ATTACHMENT NO. 1 TO AEP:NRC:0894

TECHNICAL SPECIFICATION CHANGE DESCRIPTIONS

Change No. 1

FIGURE 3.4-2

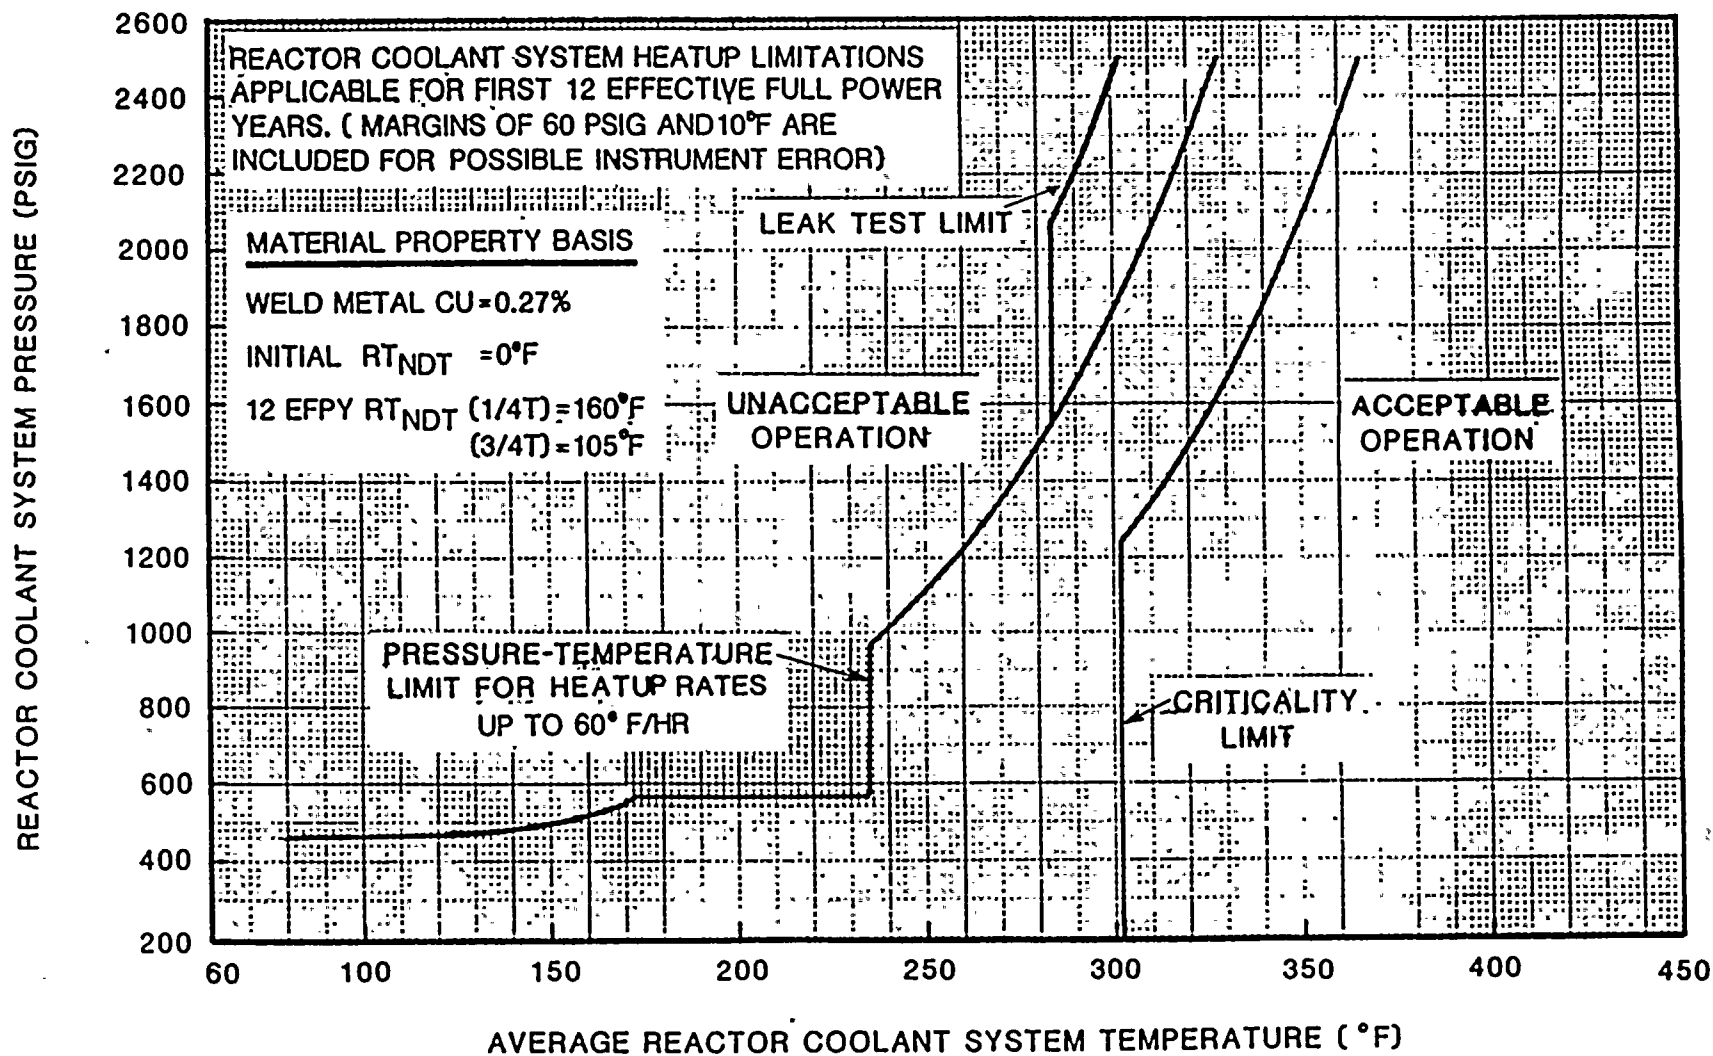
Figures 3.4-2 and Figure 3.4-3 are the heatup and cooldown curves for Unit Nos. 1 and 2. These curves are composite curves prepared based upon the most limiting value of the predicted adjusted reference temperature at the end of 12 EFPY. The revisions to the curves reflect the analyses done as a result of the capsule (Y) testing by Southwest Research Institute. The assumptions and limitations used in the development of the curves are noted in the revised bases for both Units.

The heatup limit curve, Figure 3.4-2, is a composite curve which was prepared by determining the most conservative case, with either the inside or outside wall controlling, for any heatup rate up to 60°F per hour. The cooldown limit curves of Figure 3.4-3 are composite curves which were prepared based upon the same type analysis with the exception that the controlling location is always the inside wall where the cooldown thermal gradients tend to produce tensile stresses while producing compressive stresses at the outside wall. The heatup and cooldown curves were prepared based upon the most limiting value of the predicted adjusted reference temperature at the end of 12 EFPY.

The pressure-temperature limit lines shown on Figure 3.4-2 for reactor criticality and for inservice leak and hydrostatic testing have been provided to assure compliance with the minimum temperature requirements of Appendix G to 10 CFR 50.

FIGURE 3.4-2

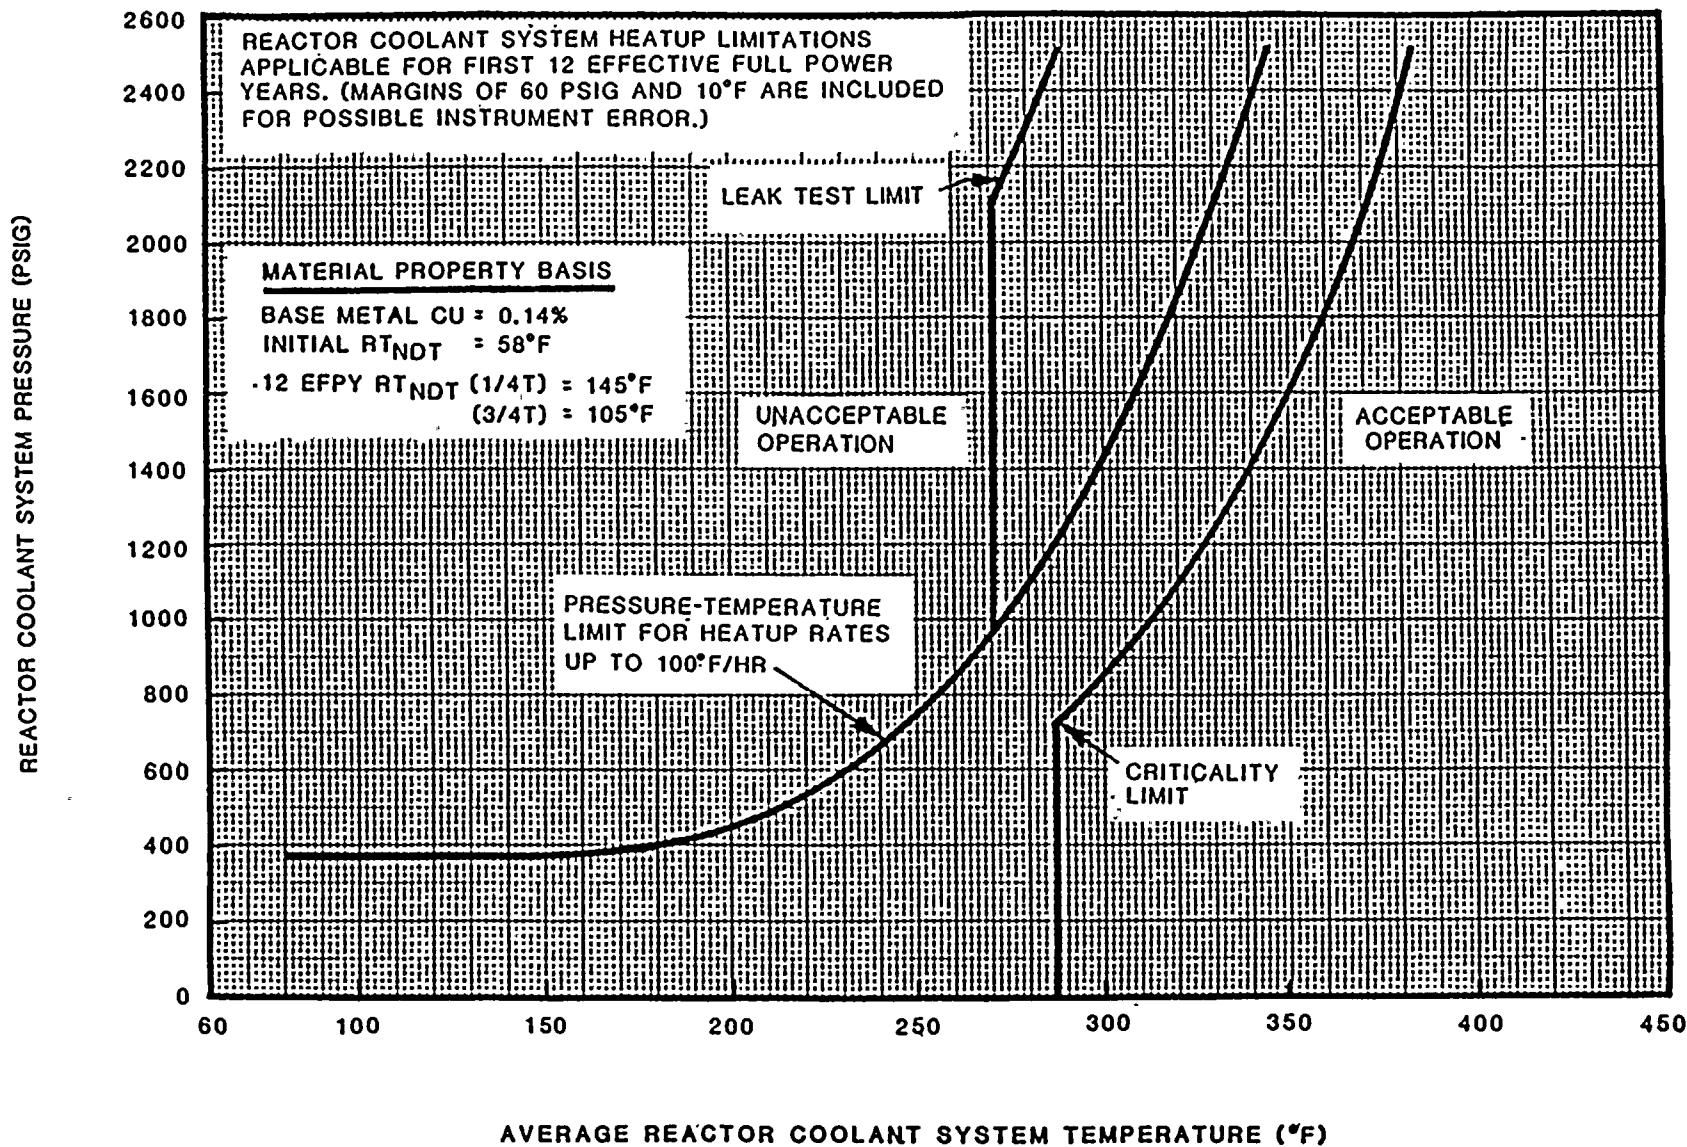
The heatup limit curve, Figure 3.4-2, is a composite curve which was prepared by determining the most conservative case, with either the inside or outside wall controlling, for any heatup rate up to 100°F per hour. The cooldown limit curves of Figure 3.4-3 are composite curves which were prepared based upon the same type analysis with the exception that the controlling location is always the inside wall where the cooldown thermal gradients tend to produce tensile stresses while producing compressive stresses at the outside wall. The heatup and cooldown curves were prepared based upon the most limiting value of the predicted adjusted reference temperature at the end of 12 EFPY.

FIGURE 1. PROPOSED MODIFICATION TO DONALD C. COOK UNIT NO. 1 REACTOR COOLANT SYSTEM PRESSURE-TEMPERATURE LIMITS VERSUS 60°F/HOUR RATE CRITICALITY LIMIT AND HYDROSTATIC TEST LIMIT, 12 EFY, FOR FRACTURE CONTROL AT STRUCTURAL DISCONTINUITIES

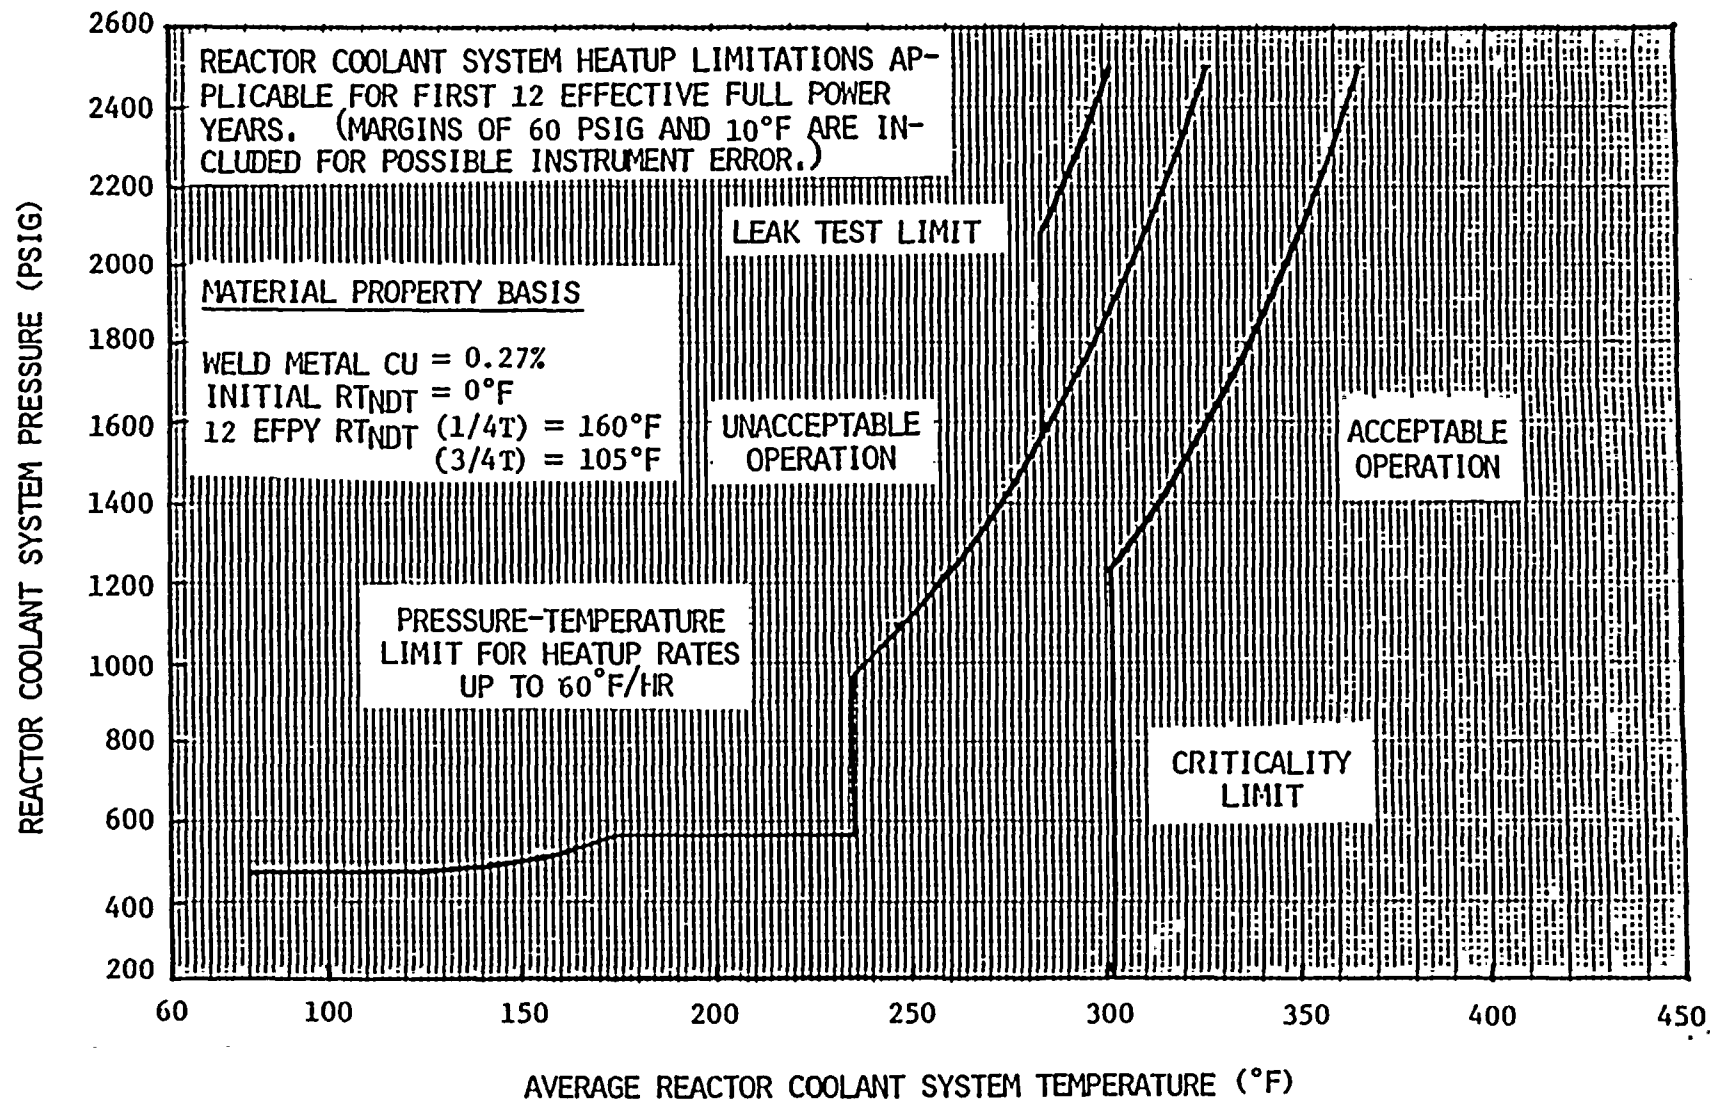
Enclosed is a revised Figure 1 for placement in the referenced letter. Although the 10°F allowance for instrument error had been included in the analysis described in the referenced letter, the -60 psi instrument error had not. Therefore, I lowered the horizontal line from 625 psi to 565 psi.
